## NOTICE OF DECISION

### 1951 Schurman Warehouse and Office

<b>Land Use Application Nos.:</b>	SPR 22-004 (Site Plan Review – Type 2) SEP 22-004 (SEPA)
<b>Applicant:</b>	Wilson Architects PLLC C/O Rusty Muyuela 404 E. 15 <sup>th</sup> St #7 Vancouver, Washington, 98663
<b>Property Owner:</b>	DT Realty LLC Mark Dawkins 610 NW 16 <sup>th</sup> Cir Ridgefield, WA, 98642
<b>Site Location:</b>	1951 Schurman Way Woodland, WA 98674
<b>Parcel &amp; Size:</b>	507870102, 3.06 Acres
<b>Zoning Designation:</b>	Light Industrial, I-1
<b>Date Application Received:</b>	October 28 <sup>th</sup> , 2021
<b>Notice of Application &amp; Likely DNS issued:</b>	Revised: May 11 <sup>th</sup> , 2022 Original: April 28 <sup>th</sup> , 2022 [See: case # SEP-22-004]
<b>Comment Period &amp; SEPA Appeal Period Ended:</b>	Revised: May 25 <sup>th</sup> , 2022 Original: May 12 <sup>th</sup> , 2022
<b>Notice of Decision Issued:</b>	May 31 <sup>st</sup> , 2022
<b>DRC Decision:</b>	Approve with Conditions

STABILIZED CONSTRUCTION ENTRANCE						E-05
APPROVED	REVISIONS	DATE	DRAWN	DESIGNED		
PUBLIC WORKS DIRECTOR		DATE

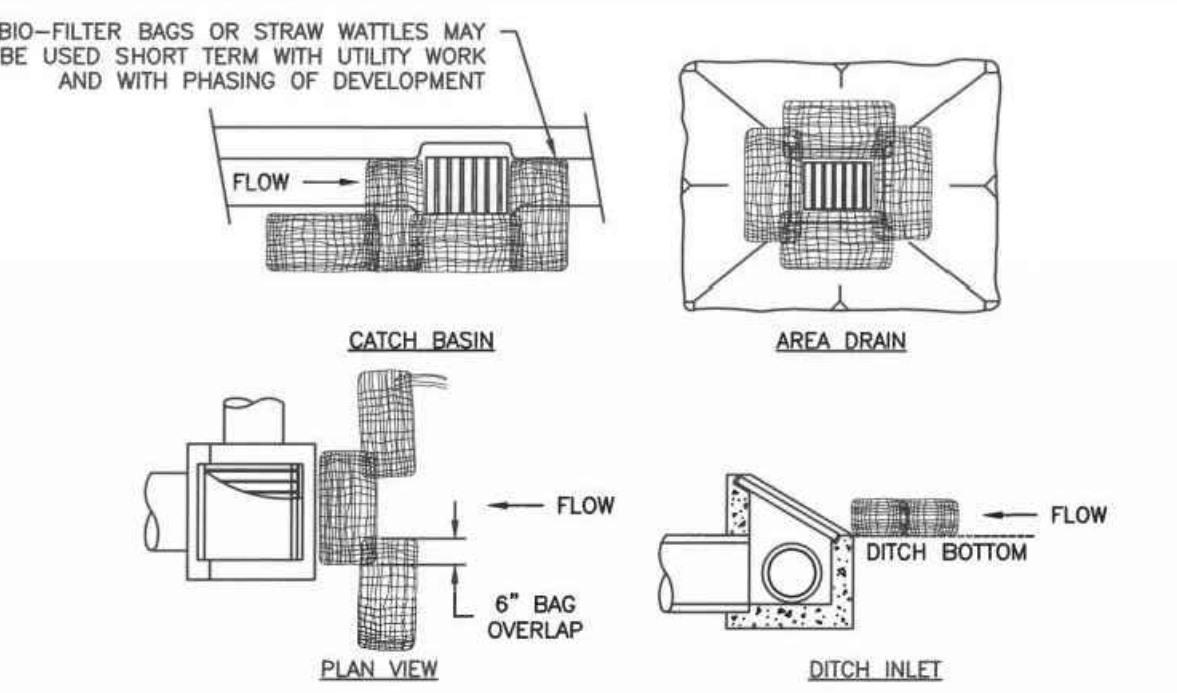
**Finding 13B:** Construction Entrance meets the width requirements as defined within City of Woodland Std. Details E-03 and E-05 but not the length requirement. The site will have more than one-acre exposed soil and the Construction Entrance shall be 100-foot minimum length. Please revise this sheet to show a minimum 20-foot wide by 100-foot-long Construction Entrance. *(See condition 11)*

11. Revise the proposed construction entrance as directed to ensure accordance with WMC.
12. A Final Stormwater Technical Information Report (TIR) is required that complies with WMC 15.12 and the 1992 Stormwater Management Manual for the Puget Sound Basin as adopted by the City of Woodland and addresses the following concerns:

**South Biofiltration Swale  
Typical Section**

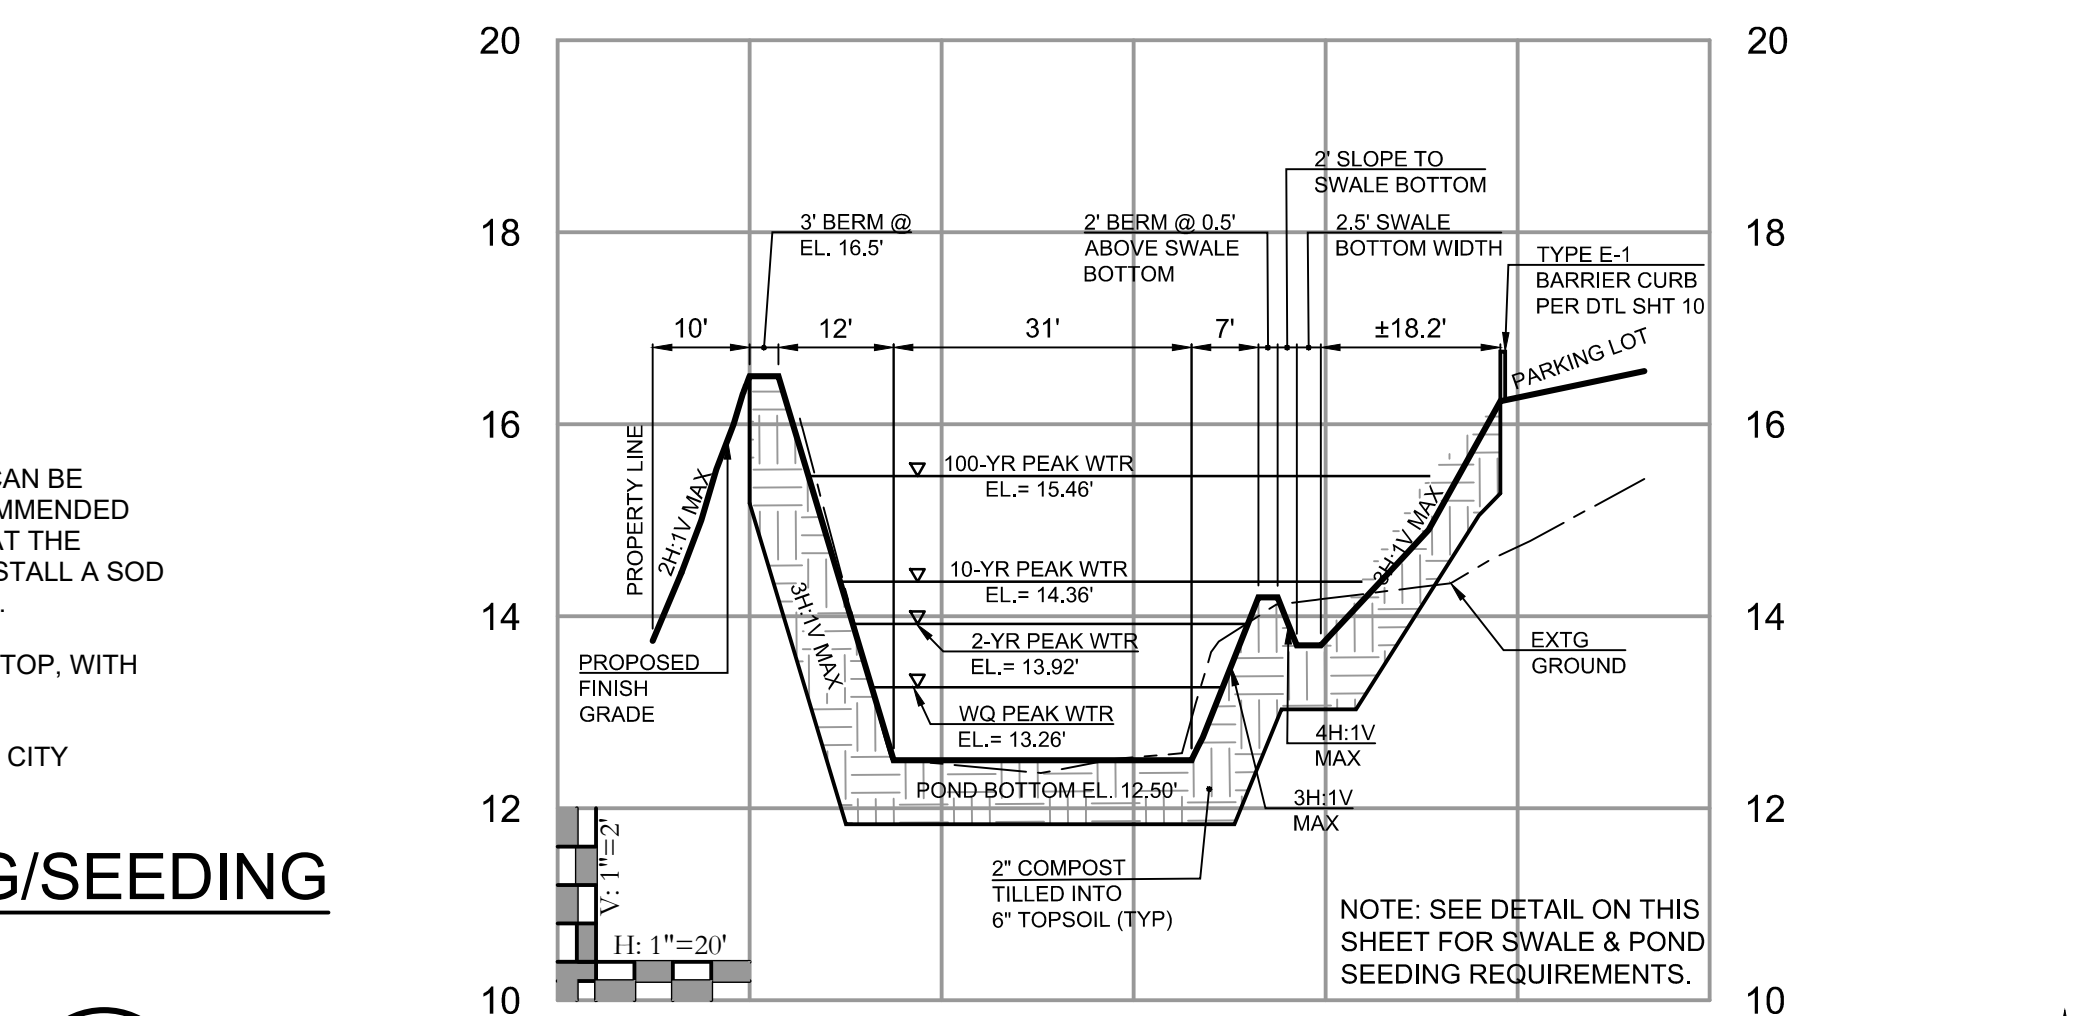
1. Woodland MC 15.12.080, Quantity Control, requires 2-, 10-, 25- and 100-year, 24-hour storm events. 25-year not included.
  - a. Add 25-year, 24-hour storm values to Table 1 and Table 2.
2. Bioswale 11R, model lists 2.5' width at bottom, plans show 2'.
  - a. Revise the HydroCAD model for 2-foot-wide swale bottom or revise plans to show 2.5-foot-wide swale bottom.
3. Per Appendix III-6.1 of the 1992 Puget Sound Manual, biofiltration swales with less than 2-percent slope should include underdrains.
  - a. Provide under drains for the biofiltration swales.

- a. Add 25-year, 24-hour storm values to Table 1 and Table 2.
  - b. Revise the HydroCAD model for 2-foot-wide swale bottom or revise plans to show 2.5-foot-wide swale bottom.

- c. Provide under drains for the biofiltration swales.
13. Applicant shall provide required information regarding projected employment at prior to civil review to confirm compliance with parking lot requirements.
